Diamantina Subdivision X

City Plan Commission — August, 28, 2025

SUMMARY OF RECOMMENDATION: Staff recommends **APPROVAL** of Diamantina Subdivision X on a Resubdivision Combination basis and **APPROVAL** of the exception request.

EXISTING CROSS-SECTION:

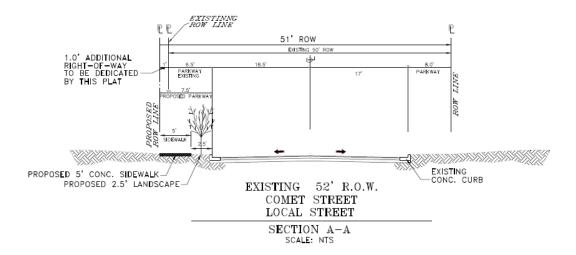
1. To waive the construction of 2.5 feet of planter strip along Comet Street.

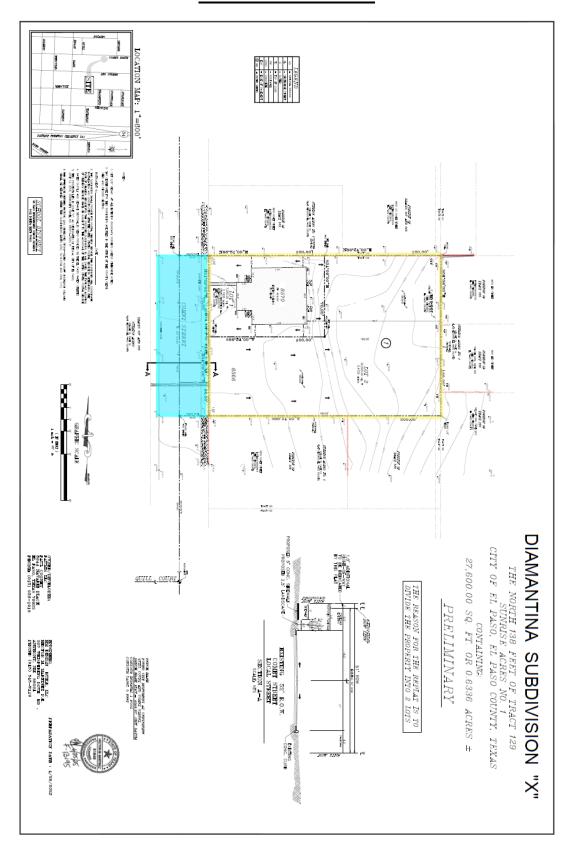
- 3. Include easements in dedication statement.
- 4. Outline the easement in the rear, it is not shown on the final plat.
- 5. Per El Paso Electric comments, please add a 10' wide utility easement along the N boundary of proposed lot 1 and 2. We have an existing line. Please also add a 10' wide utility easement along Comet Dr.

Please add a 10' wide utility easement along the N boundary of proposed lot 1 and 2. We have an existing line. Please also add a 10' wide utility easement along Comet Dr.

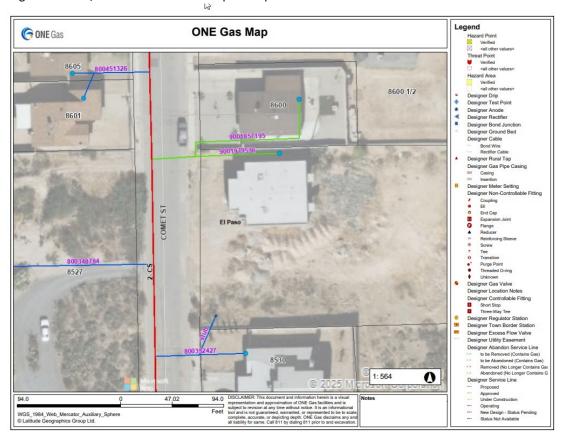
In reference to case SUSU25-00077 - Diamantina Subdivision X, Texas Gas Service has two services for 8530 & 8570 Comet St (see image below as reference).

Texas Gas Service does not allow permanent structures nor trees to be installed on top of TGS gas mains or service lines. If a conflict is anticipated, the developer, contractors or owner representative should contact TGS to relocate the gas main and/or service at the developer's expense.
